MECKLENBURG COUNTY Park and Recreation Department

MEMORANDUM

TO:	Zenia Duhaney, Associate Planner Charlotte Mecklenburg Planning Department
FROM:	Joyce Figueroa, Planner Capital Planning Services
DATE:	October 24, 2017
RE:	Rezoning Petition #2017-135 – Redwood Ridge Road (Ridge Rd.) (PID# 02972118B)

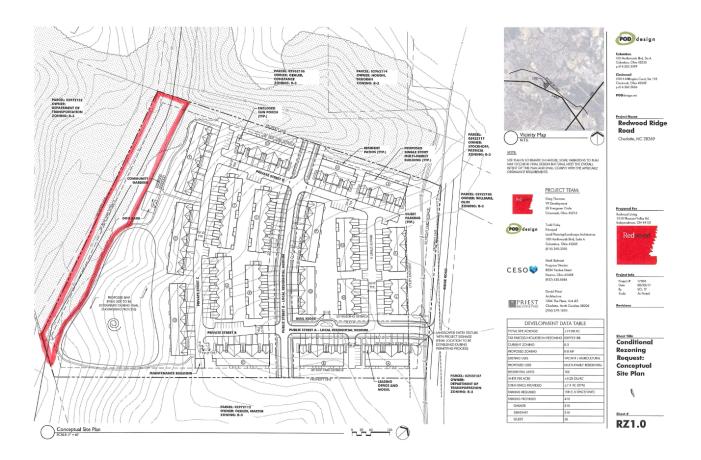
Parcel #02972118B is adjacent to the Stoney Creek Tributary Creek corridor. We request the petitioner dedicate and convey the 100' from west property line or 5' from inside of proposed trail to Mecklenburg County for future greenway use. Please see area highlighted in red below.
